Flood Control Project Maintenance Levee Inspections

Fall 2020 Levee Maintenance Deficiency Summary Report

Reclamation District No. 0765 Glide

Levee Inspection Report By Mile - Fall 2020

Photo 1 of 1 : FA_2020_RD0765_211_1_20200916_00001.jpg

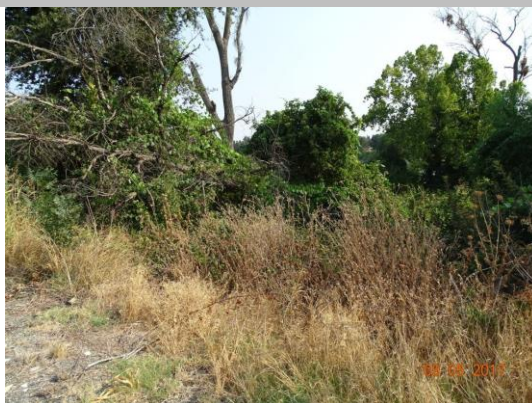
LM Start	1.58	Rating **	M	Issue No.	1
LM End	1.58	Issue Type +	Ma	Location *	WS
Category	Earthen Levee			GPS Latitude/Longitude	
				Start	End
Item	Encroachments			38.481959 °	38.481959 °
				-121.550527 °	-121.550527 °
DWR ID	DWR_RD0765_01_f _ 2017_1				
Comment Code					
TR : Tree or limb					
Inspector Comment					
Remove a fallen tree on the waterside slope.

View looking north at the fallen tree. Fall 2017
